## September 17, 2025 Council Meeting

**Addition to the Agenda Questions received from Council seeking additional information and the corresponding responses provided by staff regarding the August 27, 2025 Council agenda items.**

## **REPORT PW-2019-003**

### **Sight Lines at Intersections**

Figure 11

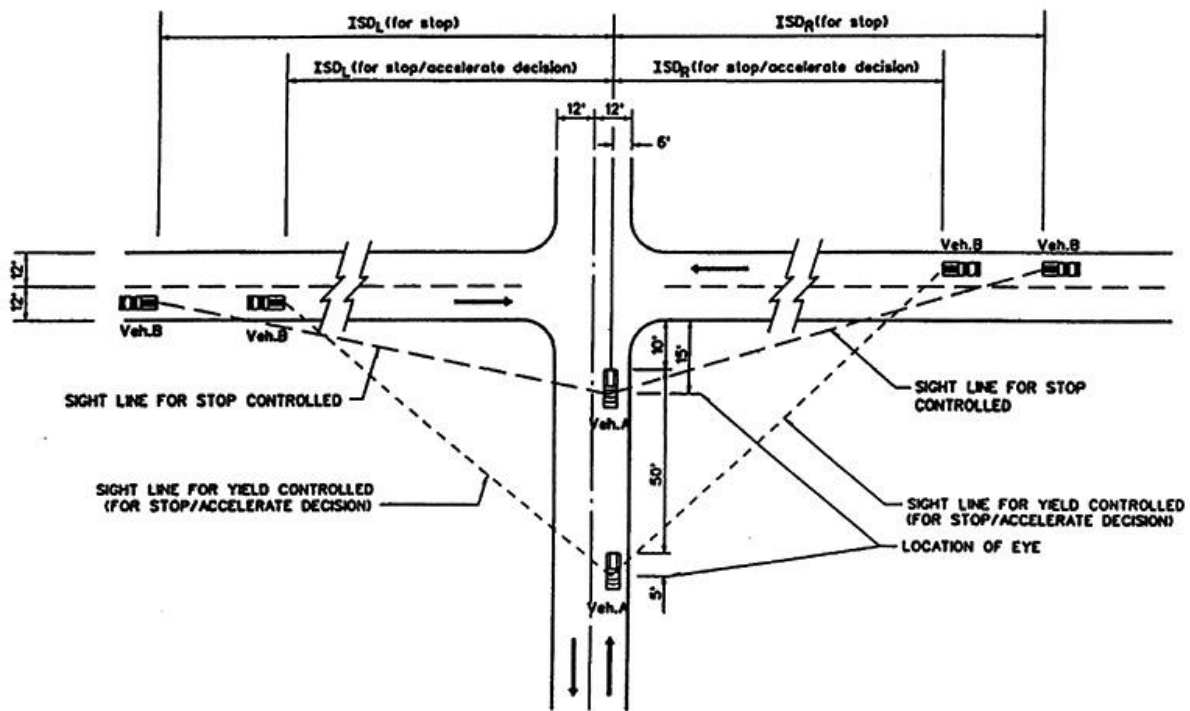
Sight lines for a stop-controlled intersection should be free of sight obstructions along said sight line as shown in Figure 11; except for appurtenances permitted by the municipality such as utility poles, traffic signs, mailboxes or similar. To layout the sight line first you would need to determine design speed. Design speed is determined during the engineering of a road project. On many township roads where a recent construction project has not been completed design speed is probably unknown. Design speed may have equaled the posted speed, or the design speed limit may be greater than posted speed. Design speed is critical on curves in the road but not on straight tangent road sections. A proxy would be to substitute the average operating speed of traffic. Next measure along the center of the lane of the road with the stop condition, (may use the shoulder for safety) 4.4m from the near side edge of pavement of the through road, which would indicate the driver's position sitting in their stopped vehicle at the intersection. Next using both Figure 12 for a left turning vehicle and Figure 13 for a right turning vehicle measure along the center of the lane (may use the shoulder for safety) the distance identified for the proxy design speed selected. This will create the sight line from the drivers position to the point measured along the center of the through lane. That sight line should be free of sight obstructions both horizontally and vertically (vertically refers to overhanging tree branches or long grass). For example, if 70km/h is used for the design speed for a left turning vehicle the Intersection Sight Distance Right ( $ISD_R$ ) (Figure 11) would equal 150m. The  $ISD_L$  distance for the right turning vehicle would equal 130m.
